UNITED STATES PATENT AND TRADEMARK OFFICE

| Office Action Summary | Application No. 10/713,788 | Applicant(s) REESE, KARL S. | |

DETAILED ACTION

FIG. 4

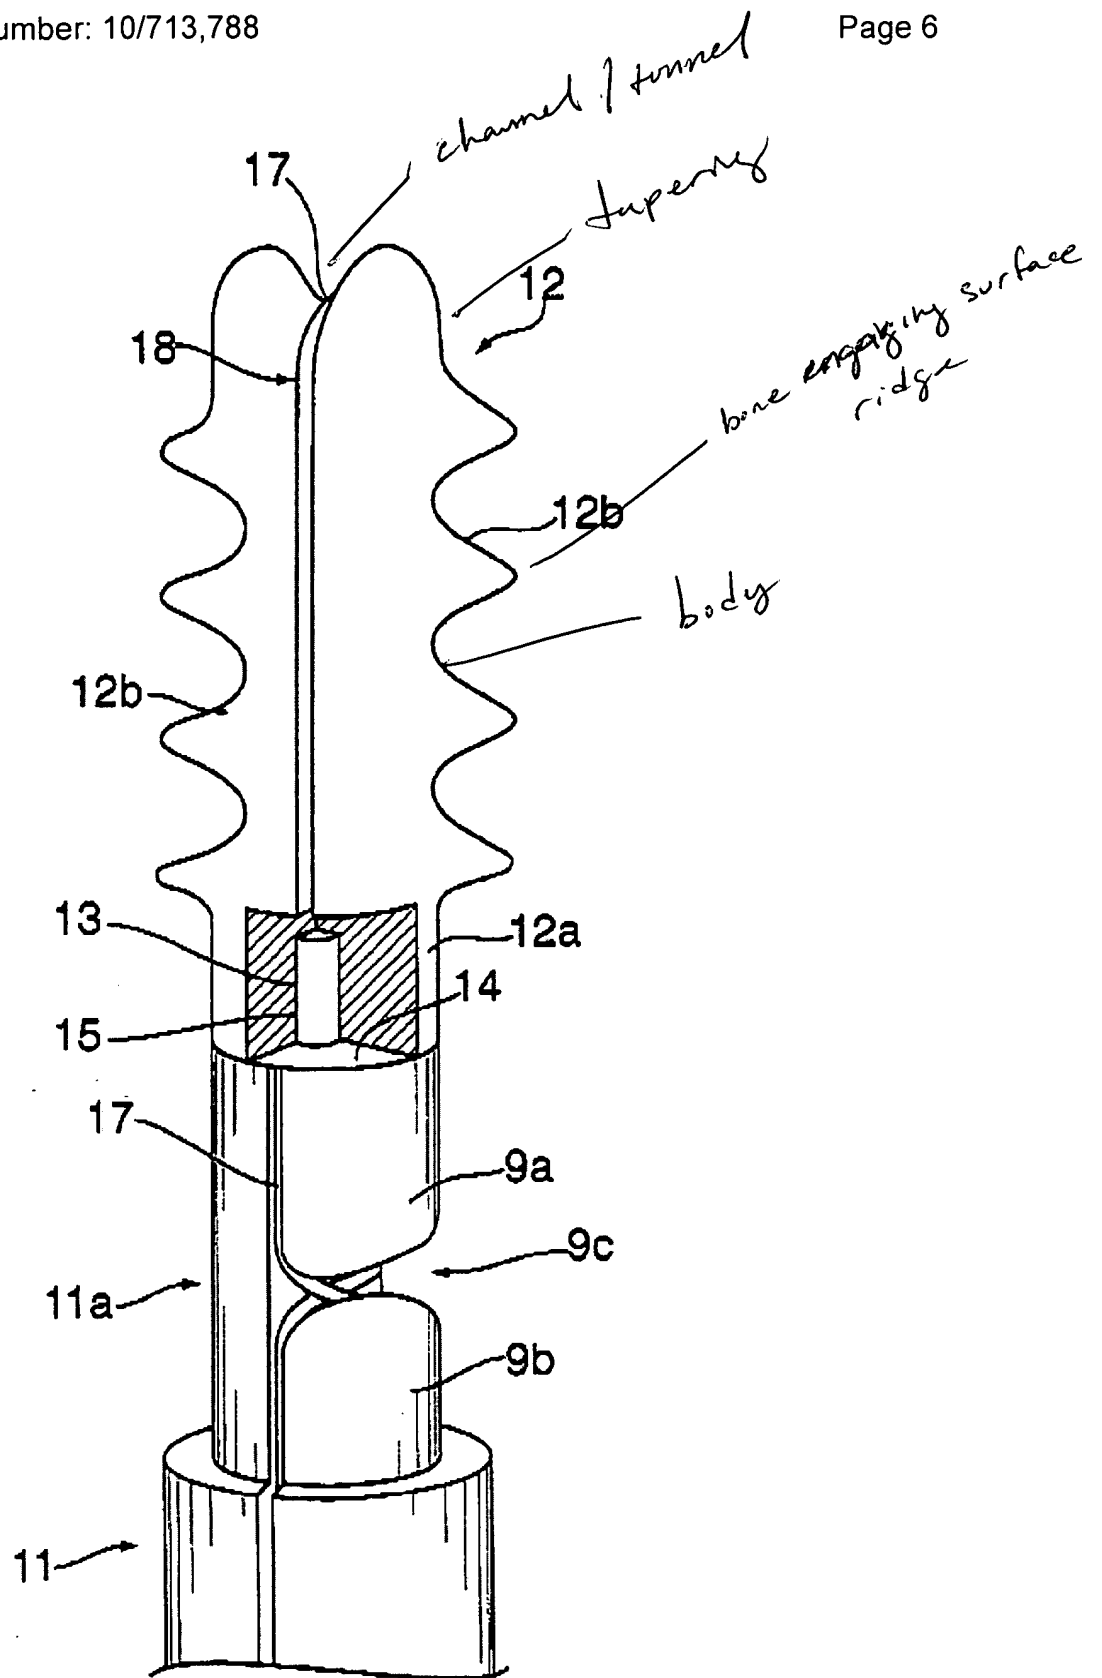
5. Claims 1-8, 10-14, 16, 17, 19, and 20-29 are rejected under 35 U.S.C. 102(b) as being anticipated by Tormala et al. 5957924.

6. Tormala et al. teaches a suture anchor adapted to be disposed within bone, comprising: an elongate body having a proximal end, a distal end, and at least one discrete bone-engaging surface feature formed thereon and adapted to engage bone; a transversely-extending suture tunnel formed proximal to the distal end of the body such that the distal end of the body has a substantially solid distal tip; first and second

opposed suture-receiving channels formed in the body and extending from the proximal end of the body and terminating at the suture tunnel; and a suture loop disposed within the first and second opposed suture-receiving channels and the transversely-extending suture tunnel, the suture loop including a proximal portion positioned proximal of the proximal end of the body; wherein the first and second opposed suture-receiving channels are in communication with the suture tunnel; wherein the elongate body includes a plurality of discrete bone-engaging surface features formed thereon and adapted to engage bone; wherein the first and second opposed suture-receiving channels are adapted to seat the suture loop flush or sub-flush with an outer surface of the body; wherein the first and second opposed suture-receiving channels are fully capable of seating and engaging the suture loop, yet allow slidable movement of the suture loop; wherein the elongate body tapers from a proximal end to a distal end; and a driver-receiving element 4 formed in the proximal end of the elongate body.
